CALIFORNIA COASTAL COMMISSION

SUBJECT: Notice of Impending Development 1-99, Pursuant to the
Pepperdine University Certified Long Range Development Plan
(LRDP) for Public Hearing and Commission Action at the meeting
of April 13-16, 1999 in Long Beach

SUMMARY AND STAFF RECOMMENDATION

EXHIBIT 3

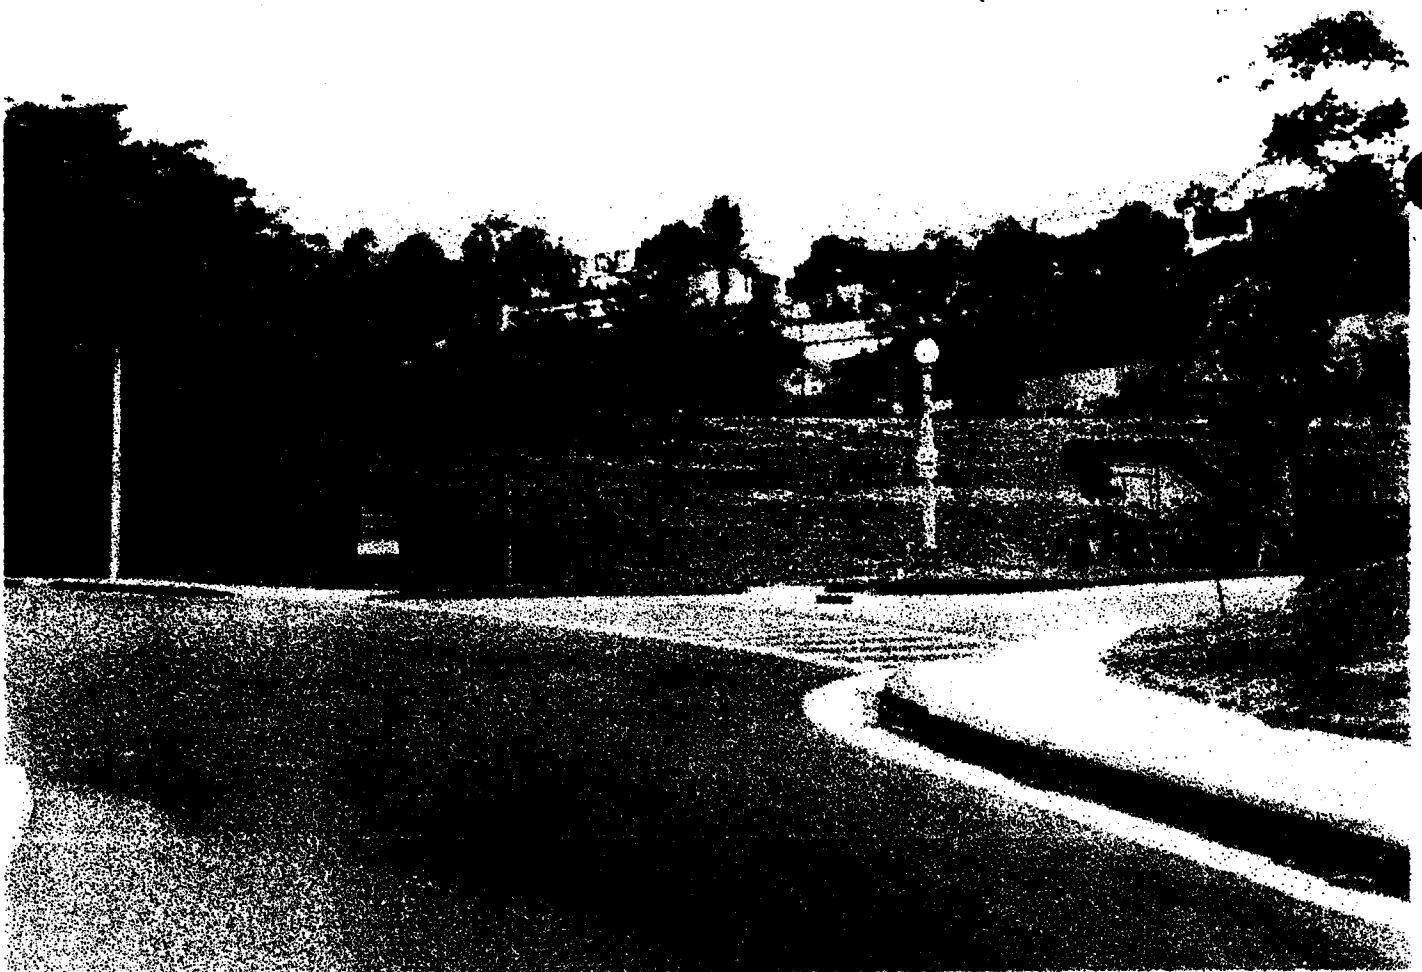
Parking Facility J is located upgrade of Banowsky Boulevard in the central, developed portion of the existing campus. There is a landscaped slope descending from the edge of the parking lot south to the street below. The University proposes to grade a cut into this slope (2,625 cu. yds. excavation and 425 cu. yds. fill) and construct wing walls in order to create a 15 foot wide access for personnel and equipment to install and maintain the flow station. As shown on Exhibit 2, the four proposed tanks will be located beneath the parking area. The mechanical room will be located beneath what is currently landscaped slope. Exhibit 3 is a photo rendering showing the appearance of the only visible portion of the project.

The impending development would be located in the existing, developed area of the campus. The proposed location of the flow station would be underground and the existing above ground tanks would be removed, resulting in an improvement to visual quality. However, the proposed grading for the new flow station and the bare slopes created by the removal of the existing station could cause adverse visual impacts if these areas are not revegetated after completion of the project. In order to ensure that the impending development is consistent with the visual resource policies of the LRDP, the Commission finds it necessary to require the University to submit a landscaping plan for these two areas, which will ensure that all graded or disturbed slopes are fully revegetated. This is included as Condition No. 2. As conditioned, the impending development will be consistent with the visual resource policies.
